CS Memorandum No. 1356

**SUBJECT:** Central Subway Program – North Beach Retrieval Shaft Site Relocation – Process, Engineering Approach, and Environmental Investigation

The diagram on the following page illustrates the differences between the SFMTA’s construction plan and the retrieval shaft as described in Karp’s evaluation.

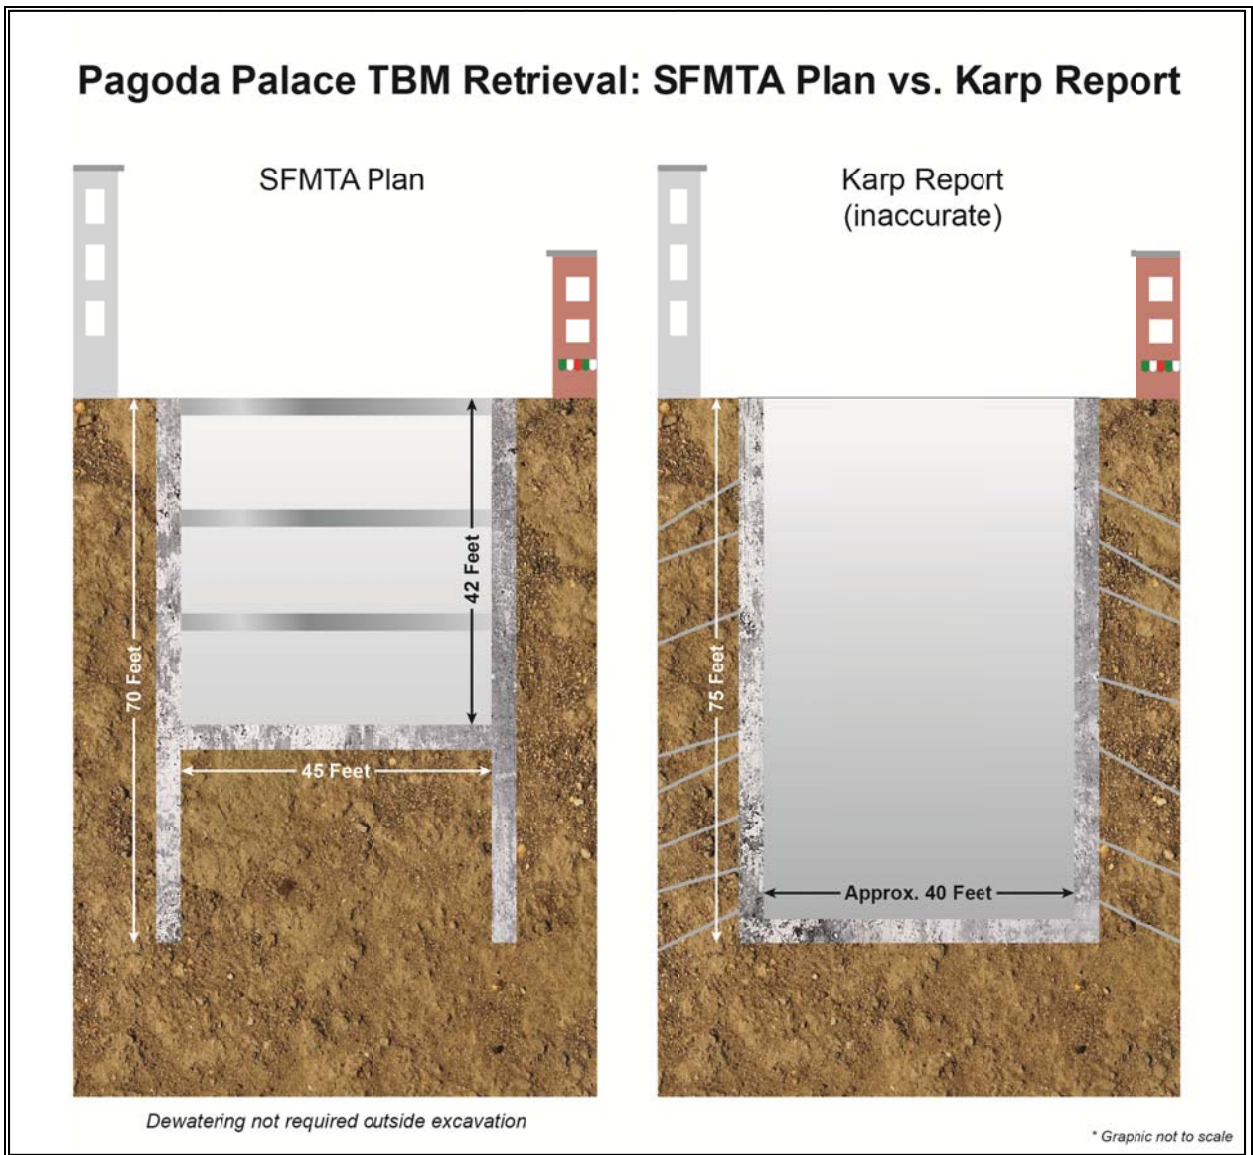
- Mr. Karp states that the excavated depth of the retrieval shaft at the Pagoda Palace will be 75 feet. This statement is incorrect. The excavated depth of the planned retrieval shaft will be approximately 42 feet.
- Mr. Karp states that the retrieval shaft cannot be braced internally because internal bracing "would interfere with TBM extraction." He further concludes that "tiebacks for soldier beams are really the only solution but tiebacks will intrude at least 40 feet into

- Mr. Karp states that constructing the retrieval shaft at the Pagoda Palace site would “require dewatering” and “will lower the groundwater table under buildings on Union, Powell, Columbus and Filbert.” This statement is inaccurate. Dewatering of excavations is a common construction method that, when performed correctly, does not cause subsidence or other adverse impacts to properties adjacent to the excavation. Dewatering will not be required outside the retrieval shaft excavation. The secant pile walls installed surrounding the excavated retrieval shaft will create a watertight barrier between the excavation and the soils and groundwater around it. The walls, which will extend to a depth of approximately 70 feet, will be constructed using interlocking concrete secant piles. The piles will be drilled into the ground before excavation begins.

neighboring lots.” This statement is inaccurate. The retrieval shaft will be braced from the inside. Steel walers will stabilize the excavation at several levels. The bracing will be installed in such a way that it does not interfere with the entry of the TBMs into the excavated retrieval shaft. This construction method requires no external shoring or intrusion into neighboring properties.

As planned, the secant piles will be drilled to a depth of approximately 25 feet below the depth of the retrieval shaft, which should block most, if not all, ground water from the excavation. Any water that might seep in would be minimal and would be removed without impact to surrounding properties.
